RESOLUTION HOLDING HEARING ON REQUEST FROM HILLTOP HOUSING, LLC (OWNER) TO AMEND PLANDSM FUTURE LAND USE DESIGNATION AND APPROVE A 1ST AMENDMENT TO THE "HILLTOP APARTMENTS" LEGACY PUD CONCEPTUAL PLAN FOR PROPERTY LOCATED AT 3722 & 3726 HUBBELL AVENUE AND 3680 & 3688 KENNEDY DRIVE

Communication from the City Plan and Zoning Commission advising that at their February 18, 2021 meeting, the following action was taken regarding a City initiated request from Hilltop Housing, LLC (owner) represented by J.B. Conlin (officer) for the 1st Amendment to the "Hilltop Apartments" Legacy PUD Conceptual Plan to allow construction of two 42-unit household dwellings in place of the approved dwelling units within a 30-unit household dwelling, a 36-unt household dwelling, and several two-household dwellings. The amendment would not alter the total number of dwelling units (254) allowed within the development.

CONCEPTUAL PLAN FOR HILLTOP APARTMENTS

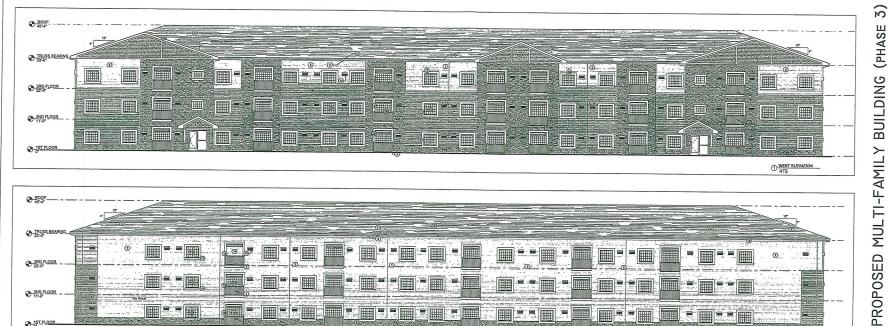
- 1. Provision of a note to state that any "thru-wall air condition unit" shall be designed and colored to blend with the building; and
- 2. Sheets 2 and 3 of the PUD Conceptual Plan shall be revised to demonstrate the existing sidewalks along Hubbell Avenue, as well as the existing shelter for the transit stop; and

- 4. The notes on Sheet 2 pertaining to the landscape buffer shall be clarified to state that the proposed 6-foot tall fence shall be 100 % opaque; and

- 1. Provision of a note to state that any "thru-wall air condition unit" shall be of a design and color that blends with the building.
- 2. Sheets 2 and 3 of the PUD Conceptual Plan shall be revised to demonstrate the existing sidewalks along Hubbell Avenue, as well as the existing shelter for the transit stop.

- 4. The notes on Sheet 2 pertaining to the landscape buffer shall be clarified to state that the proposed 6-foot tall fence shall be 100% opaque (solid).

- 3. Sheets 2 and 3 of the PUD Conceptual Plan shall be revised to demonstrate the existing sidewalks along Hubbell Avenue, as well as the existing shelter for the transit stop.

- 5. The notes on Sheet 2 pertaining to the landscape buffer shall be clarified to state that the proposed 6-foot tall fence shall be 100% opaque (solid).

- 3. Landscaping: The proposed "PUD" Conceptual Plan demonstrates significant landscaping and plantings throughout the site. It also provides a 30-foot wide landscape buffer along the east property line and a 20-foot wide landscape buffer along the north property line. Both buffers would contain a 6-foot tall fence, as well as 4 overstory trees and a mix of at least 8 additional evergreen, ornamental, or overstory trees, per 100 lineal feet. Staff recommends that the note be clarified to state that the fence within the buffers would be 100% opaque (solid). The proposed "PUD" Conceptual Plan states that the site will be landscaped in accordance with the landscaping regulations applicable in the "R-3" District. Staff recommends that this note be revised to state that the site will be landscaped in accordance with the landscaping regulations applicable in the "NX3" District.

A PLANNED UNIT DEVELOPMENT IN THE CITY OF DES MOINES, COUNTY OF POLK, STATE OF IOWA SHEET 5 OF 10 AMENDMENT #1

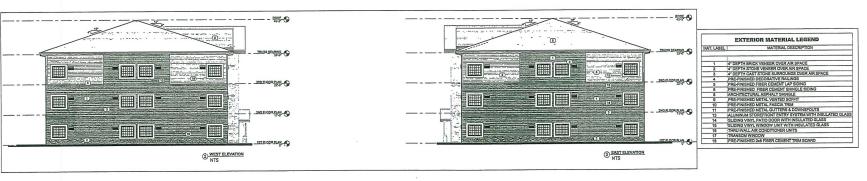
- 1. The elevations for the two new structures, as provided on Sheets 5 & 6, shall be revised so that stone and brick masonry cover at least 2/3 of all facades.
- 2. Provision of a note to state that any "thru-wall air condition unit" shall be designed and painted to blend with the building.

1. Urban Design: The proposed amendment to the PUD Conceptual Plan would allow construction of two (2) new multiple-household structures. One of the structures would be oriented north-to-south within the eastern portion of the property and the other would be oriented east-to-west within the northern portion of the property. The elevations demonstrate that the buildings would generally match the architectural character of the four (4) existing multiple-household dwellings on the site. However, the elevations demonstrate that the east façade of the easternmost building and the north façade of the northernmost building would only have a masonry wainscot. Given the visibility of these buildings from the residential uses to the east, Staff recommends that stone and brick masonry be provided on at least 2/3 of all facades instead of the wainscot so that the materials are consistent on all facades.

The elevations demonstrate that there would be "thru-wall air conditioning units". Staff recommends that a note be added to state that these shall be designed and painted to blend with the buildings.

JB Conlin 3721 SW 61st Street, stated the back building has been changed to senior living units. Both buildings will have applications to IFA so these were designed to be built together or separately depending on what is approved by IFA. They would rather follow the requirements by IFA, which is 50% of brick on the building. The back of these buildings will hardly be seen and with brick being expensive makes it seem like a luxury that would cause rent prices to rise. Regarding condition #2, they will use a powder coated metal screen for the air conditioners that will match the color used on the buildings.

<u>Jason Van Essen</u> stated staff was looking for consistency in the materials used between the existing buildings and the proposed buildings. Staff was not aware of how much the grade would be cut into with the project, which will obscure views of the back side of the buildings from the adjoining property. With seeing the graphic from the applicant showing the need for a retaining wall, staff is comfortable with what is proposed.
